# BV1 Block Diagram

REV : 3A

Revision	Date	Phase	Change List	Release Schematic Date	Release Gerber File Date
1A	12/28 2004	DV	Initial release	12/28 2004	12/28 2004
2A	02/28 2005	SIV	See page 69 Record A-1 ( EC A01 - EC A52 ) See page 70 Record A-2 ( EC A53 - EC A106 ) See page 71 Record A-3 ( EC A107 - EC A130 )	03/07 2005	03/07 2005
3A	04/19 2005	SIT	See page 72 Record B-1 ( EC B01 - EC B?? )	05/09 2005

**BV1 / M-Note Schematic EC Tracking Record A ( for DV --> SIT ) Dec. 28, 2004**

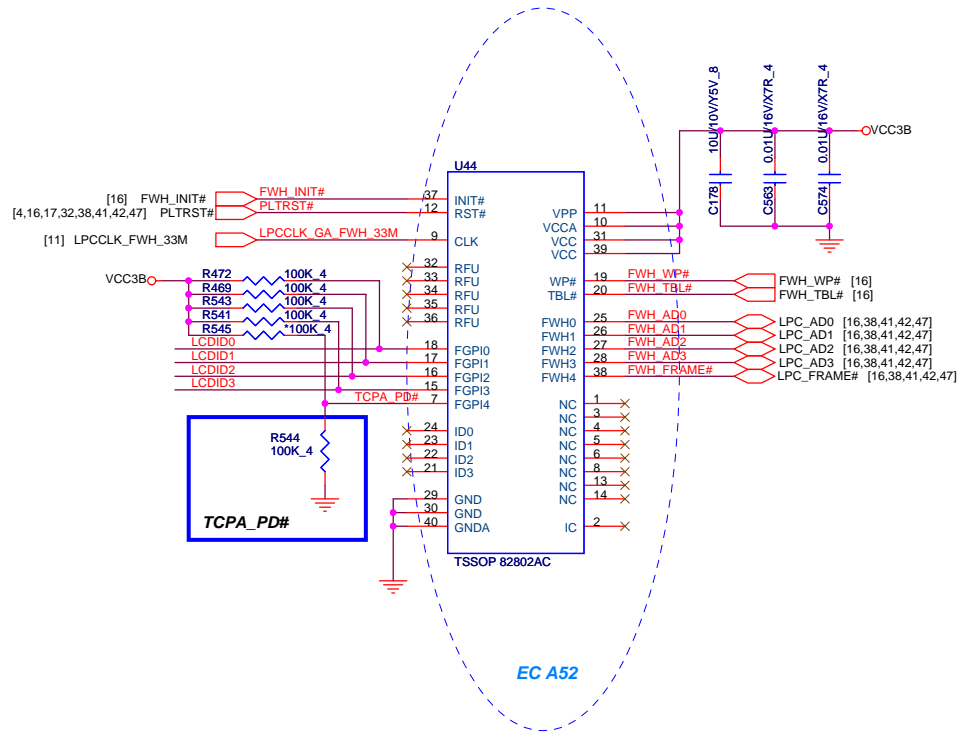
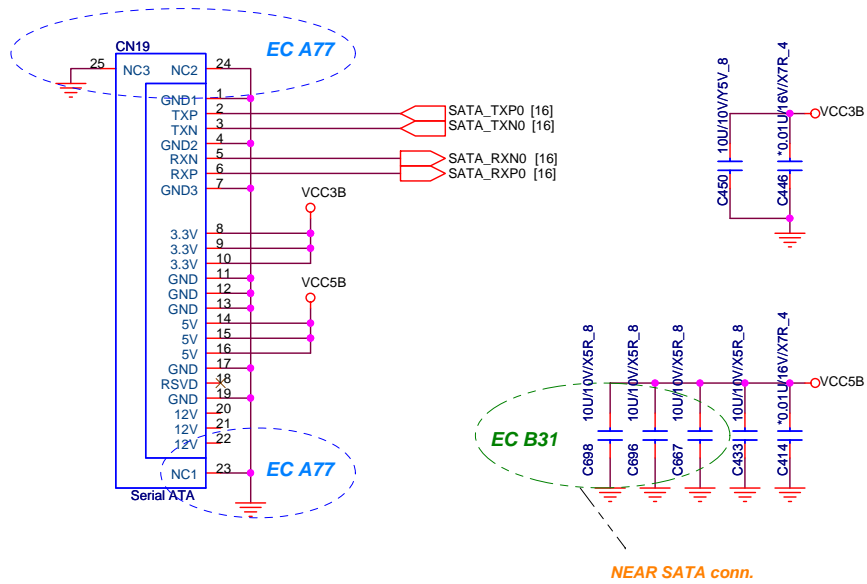
11/24 Change BT1 to be Tyco "1470366-2" and use cable-type coin battery

Size Custom	Document Number	<b>Docking</b>	Rev <b>3A</b>
Date: Tuesday, May 10, 2005	Sheet 37	of 72

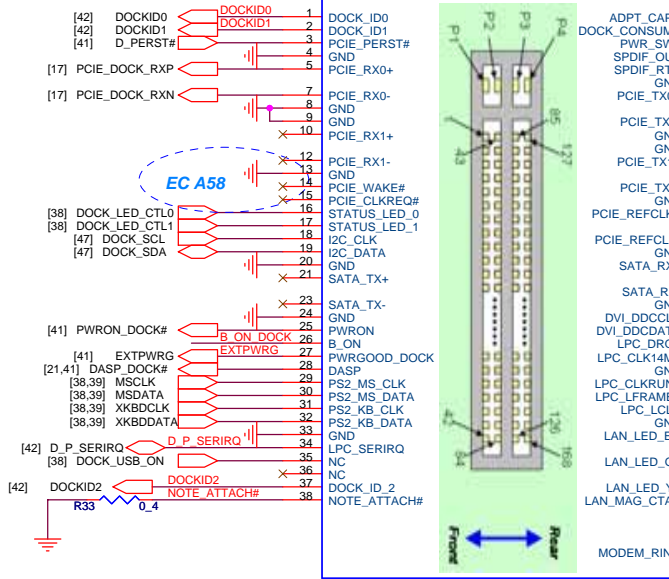
EC A106

EC A72

- EC A70/24/ Change R525 to NO ASM. ( SIV-IBM-23 )
- EC A71/24/ Change micphone selection circuit. ( SIV-IBM-23 )
- EC A72/37/ Change net name from DOCK\_MICIN\_DTCT to DOCK\_MICIN\_DTCT# , DOCK\_HPOUT\_DTCT to DOCK\_HPOUT\_DTCT#. ( SIV-IBM-29 )

- EC A106/37/ Add bypass cap on docking signal for EMI request.

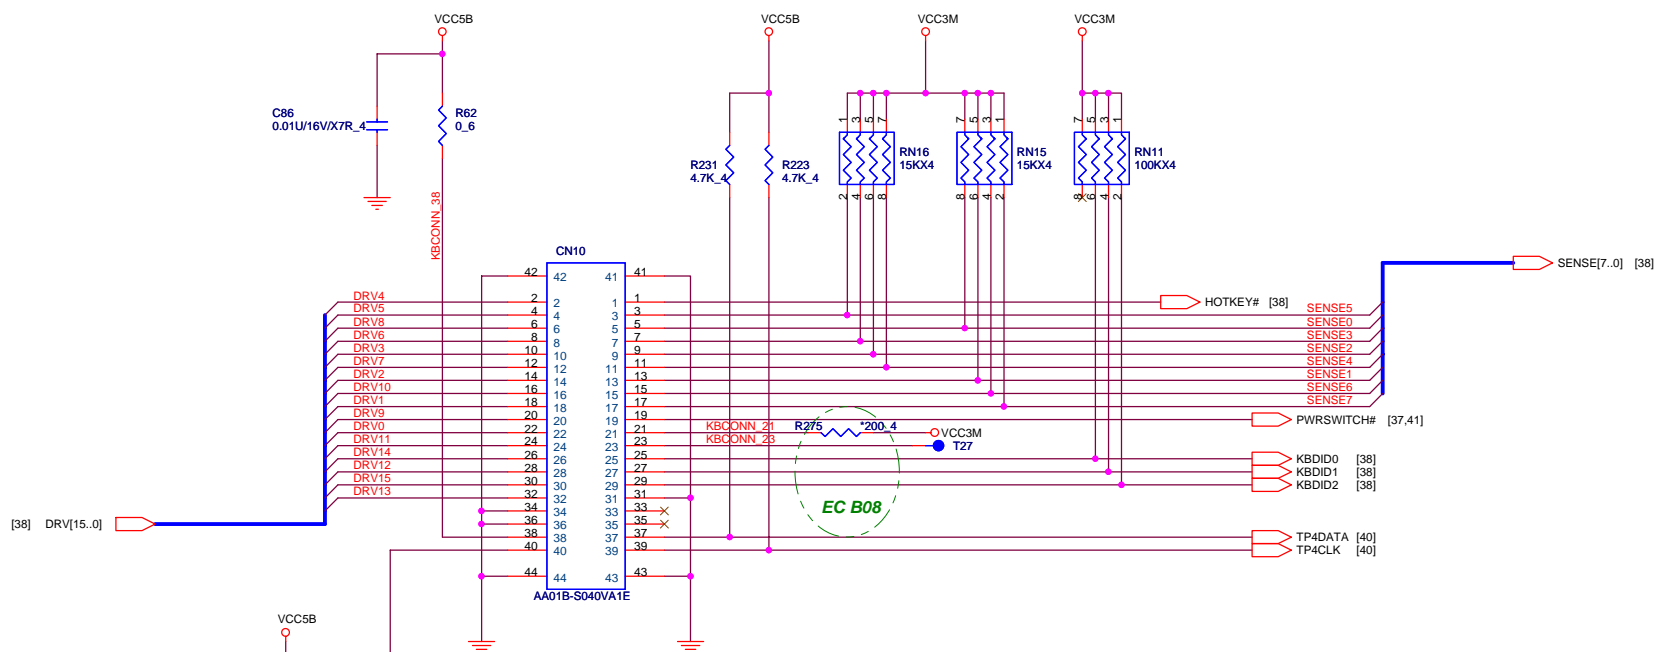
EC A105

- EC A103/49/ Prepare to support new STMicro G-sensor. ( SIV-IBM-43 )
- EC A104/14/ Add bypass cap and delete some caps on LCD signal for EMI request.
- EC A105/39/ Add bypass cap on KB signal for EMI request.

<b>PROJECT : BV1</b> <b>Quanta Computer Inc.</b>		Rev
		<b>3A</b>
Size	Document Number	Super IO
Custom		
Date:	Monday, May 09, 2005	Sheet 42 of 72

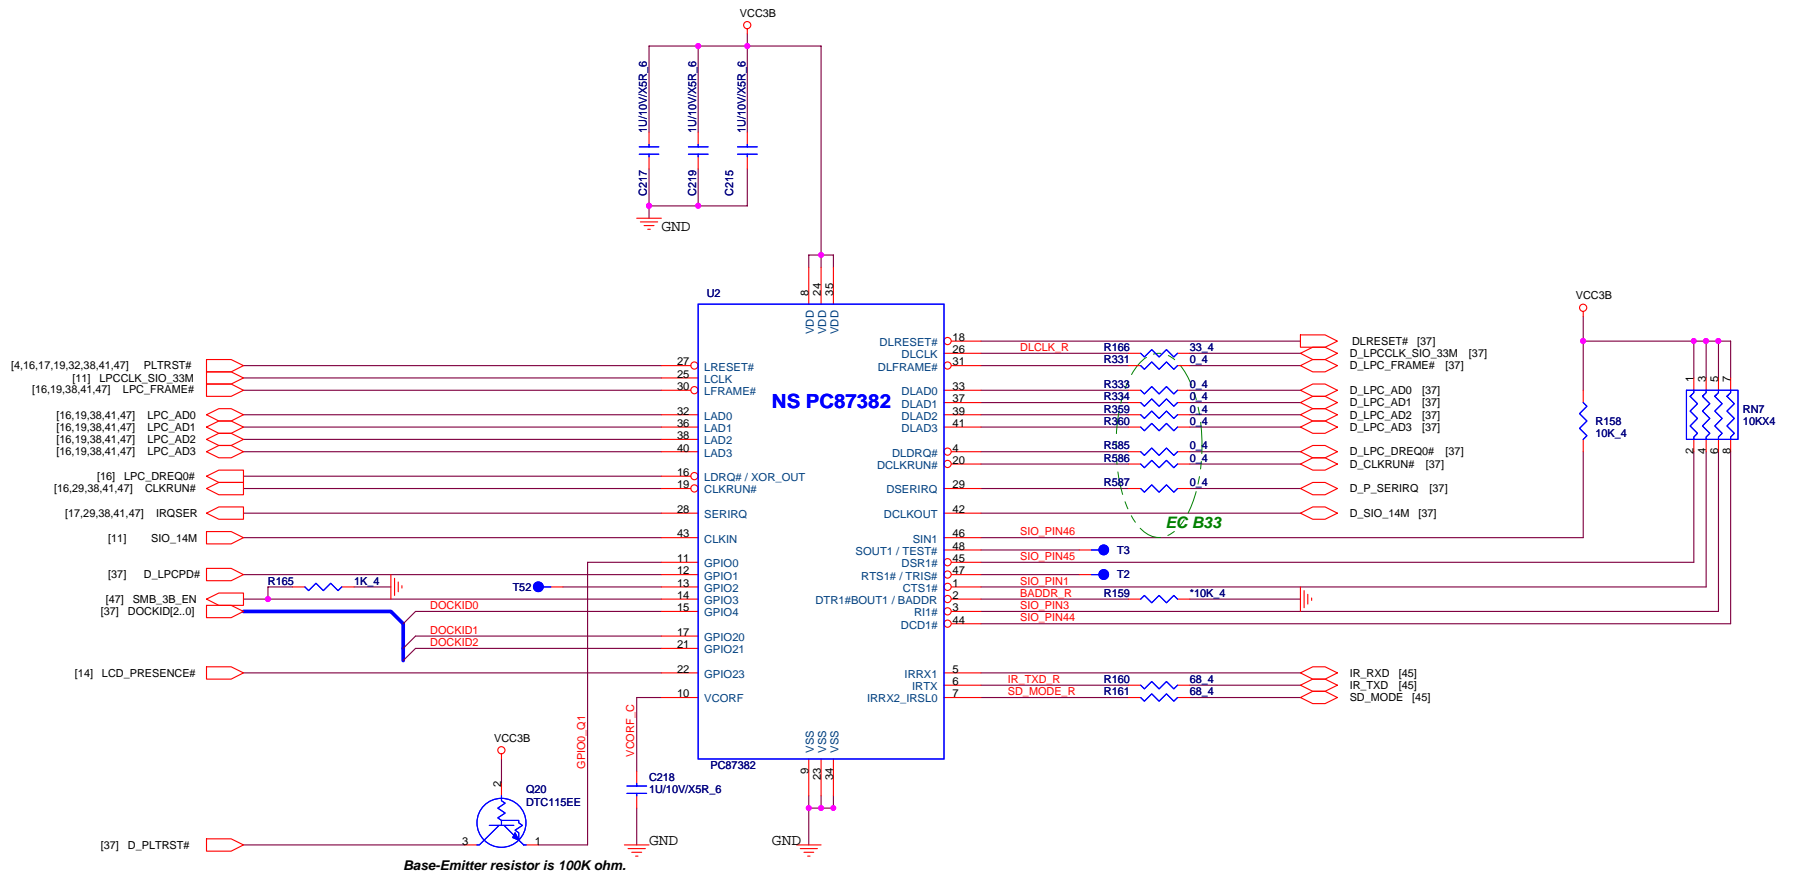
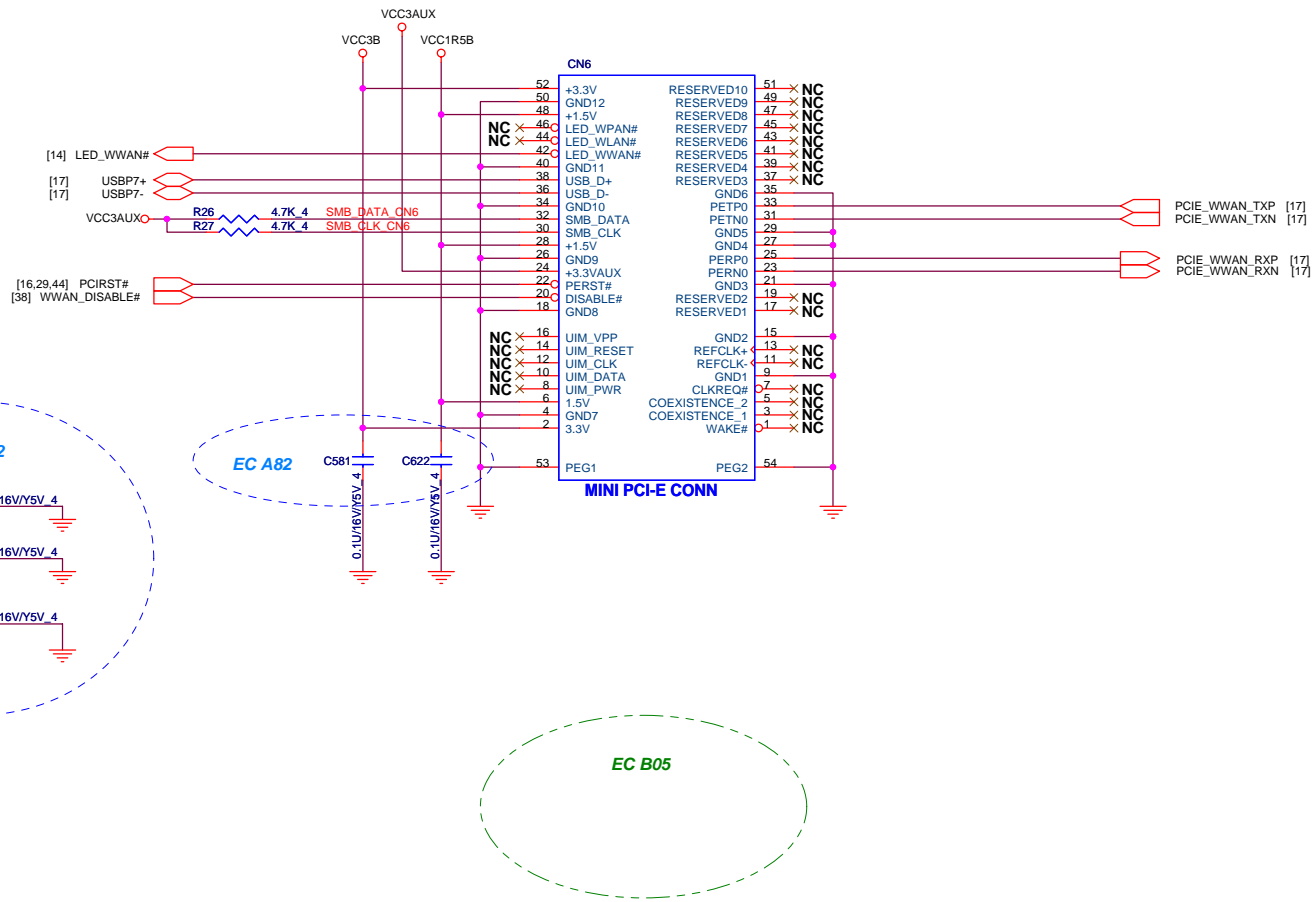
11/24  
SOLENOID\_ON# is removed from docking IF

Size Custom | Document Number | G-Sensor | Rev 3A

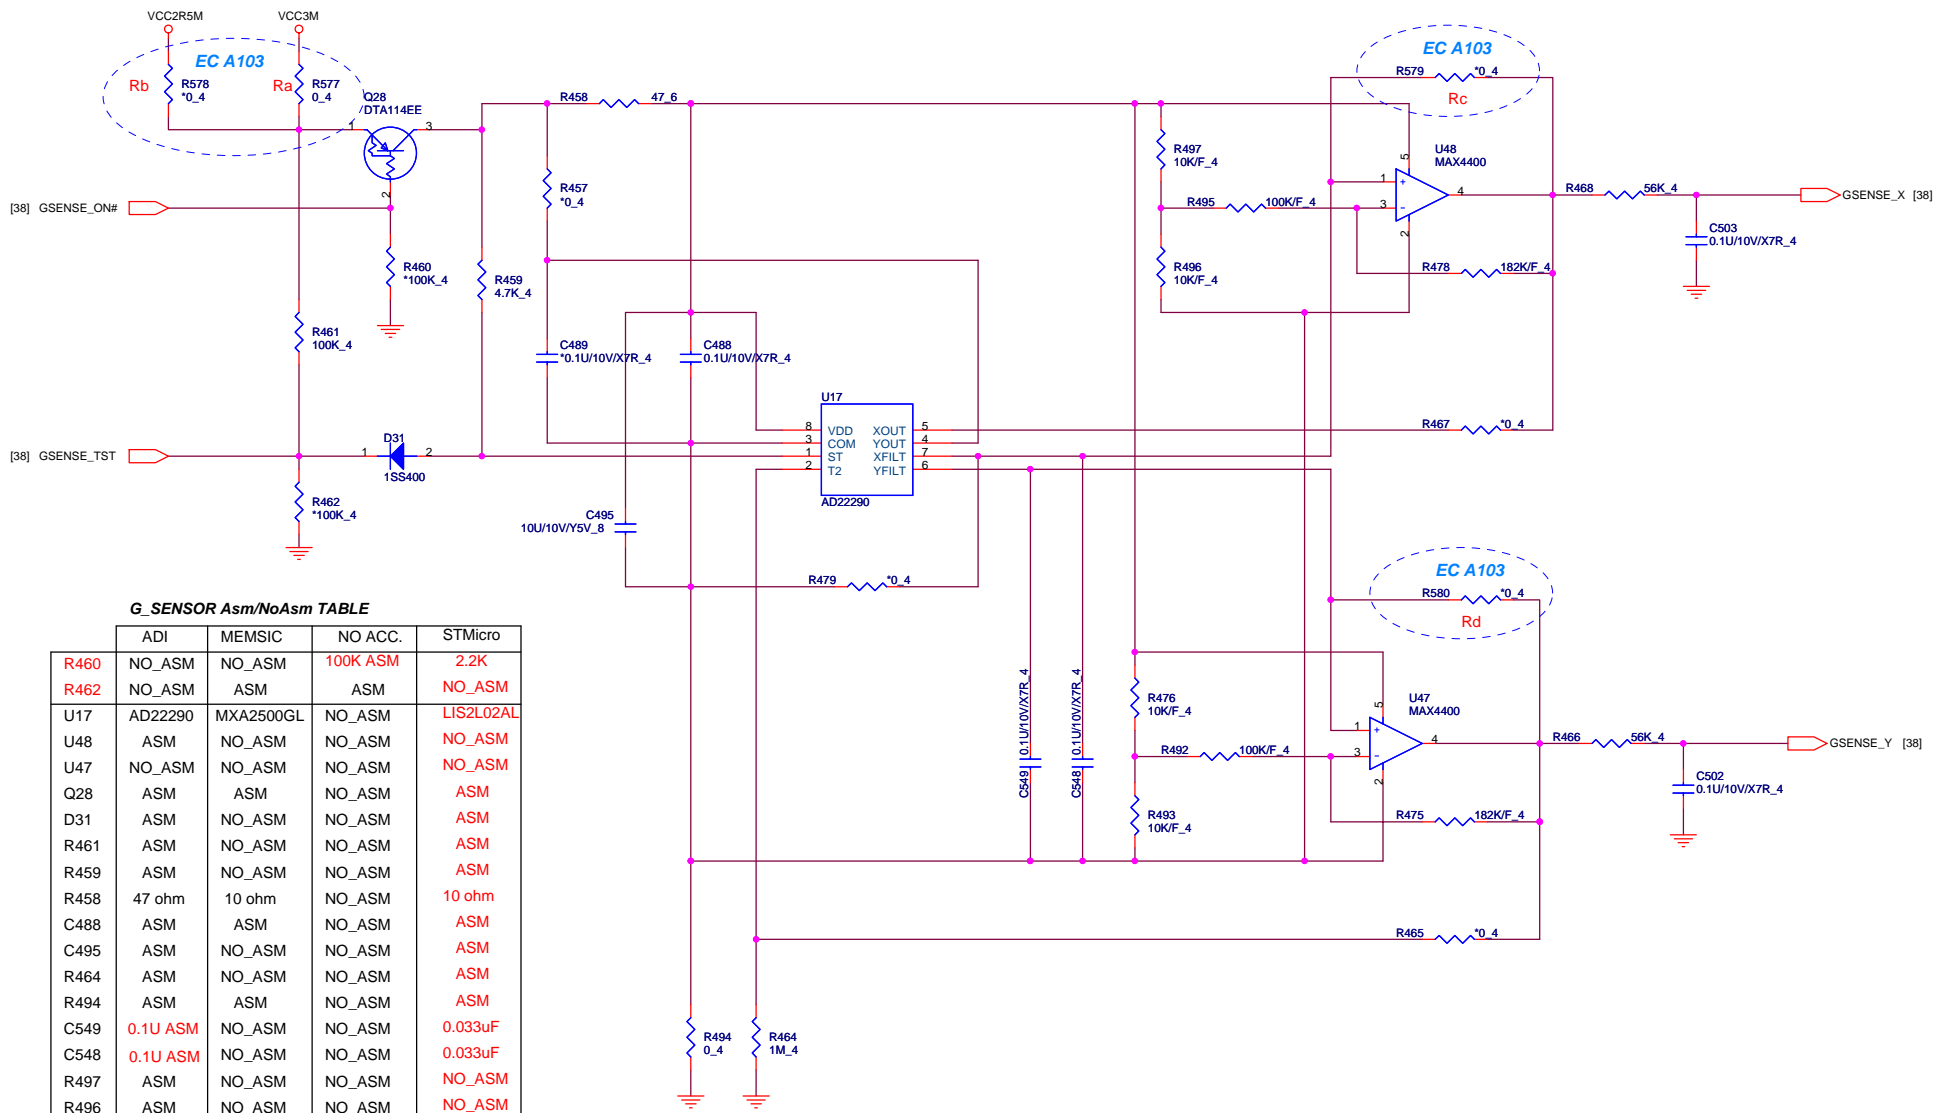
EC B41

- EC B39/11/ Change PCICLK 33MHz circuit for signal quality.
- EC B40/19/ Remove G2 short pad for IBM request.
- EC B41/49/ Correct G-sensor STMicro table as same as ADI.

<b>PROJECT : BV1</b> <b>Quanta Computer Inc.</b>	
		Size A3 Document Number <b>MAX1993 1.8V</b>	Rev <b>3A</b>
Date: Monday, May 09, 2005		Sheet 58 of 72

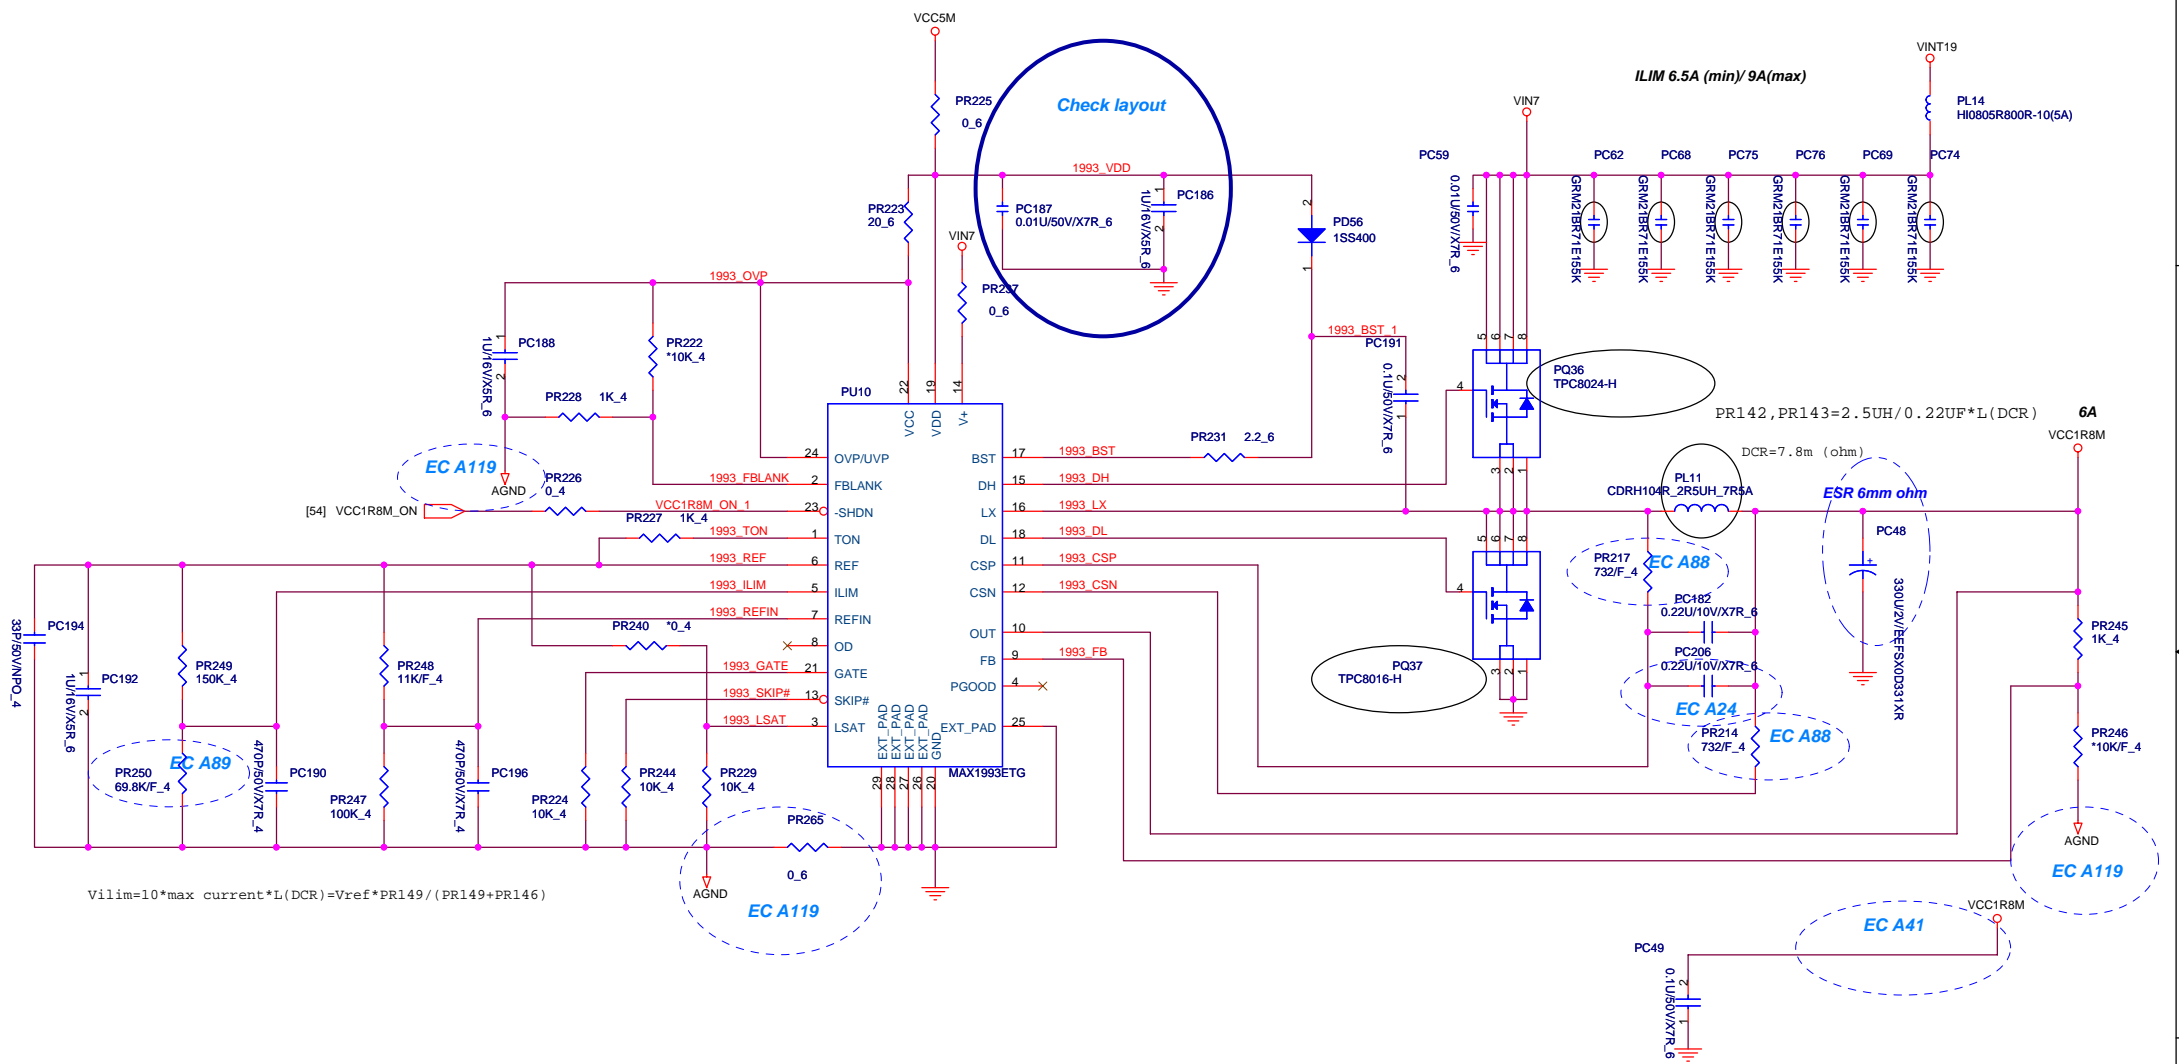
EC A41

- EC A40/17/ Change PlanarID [3..0] from 0000 to 0001. ( SIV-IBM-11 )
- EC A41/55,58,59,61,64/ Delete solder jumpers of power pads. ( SIV-IBM-13 )
- EC A42/38/ Delete dock\_attach# pull high resistor 100K R96 and charge\_current0 pull high R454.
